## Memorandum

<b>To:</b>	Chris Garrett, P.HGW.	<b>Date:</b>	August 8, 2012
<b>Company:</b>	SWCA	<b>From:</b>	Vladimir Ugorets, Ph.D. Larry Cope, M.S. Corolla Hoag, R.G.
<b>Copy to:</b>	Dale Ortman, P.E.	<b>Project #:</b>	183100.020/Task 600
<b>Subject:</b>	Pt. 3 SWCA Questions 1 through 3 - Professional Opinions to Assess Impacts to Distant Surface Waters and Modeling Certainty

Figure 2 Predicted drawdown 1,000 years after end of mining operation by M&A model [Base Case scenario with results of sensitivity analyses (Source: Figure 119 in M&A, 2010)].

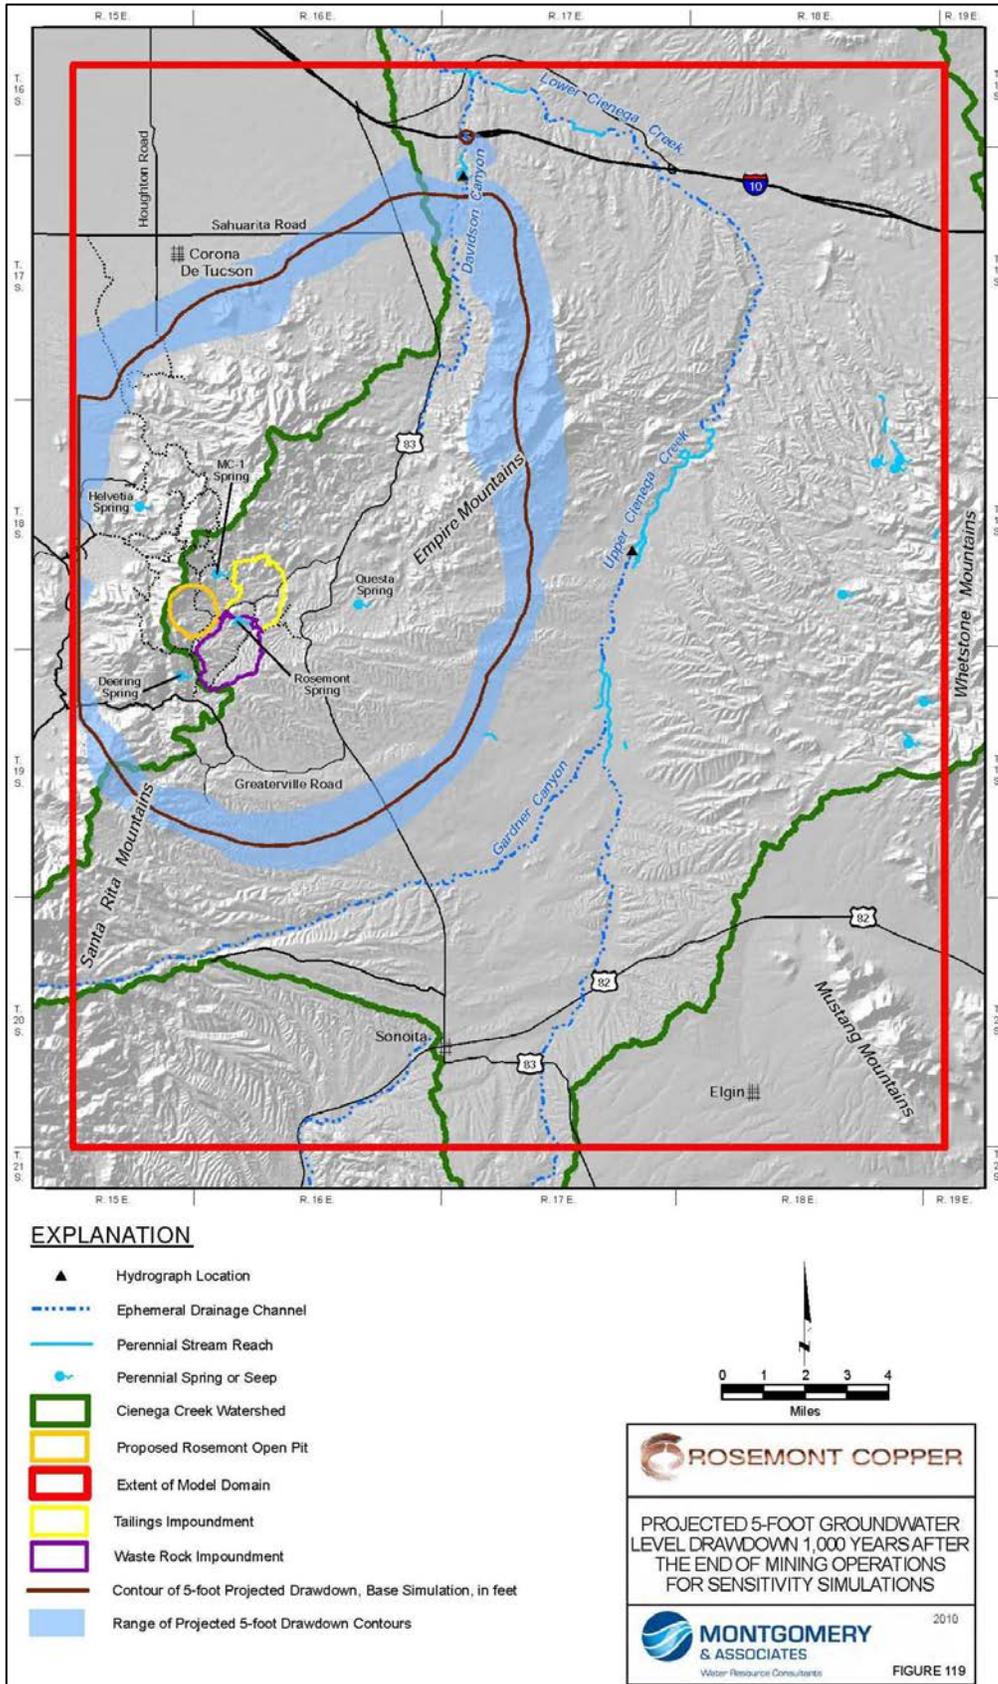
the predicted 5-ft contour of drawdown (Figure 2 and Figure 3, respectively) with a range of possible variation of the contours based on sensitivity analysis (M&A model only).

It is SRK's opinion, that the 5-ft and 10-ft drawdown contours represent the precision of regional groundwater models that can be most relied upon. That is, the models can reliably predict impacts down to perhaps 5 feet of change. Uncertainty in results increases with predictions less than these contour intervals. Thus, after addressing problems with boundary conditions along the western model boundary (both models, as described in SRK, 2012a) and simulation of the quartz latite porphyry dike (in the Tetra Tech model), the groundwater models would be reasonably able to predict changes in water levels and flows of surface-water bodies inside the 5-ft to 10-ft drawdown contours.

Based on this and existing uncertainties in parameters such as hydraulic connection between groundwater and Cienega Creek (M&A and Tetra Tech), SRK's professional opinion is that the existing groundwater flow models or any other mathematical models are not capable of predicting these impacts to the accuracy implied by the reported values.
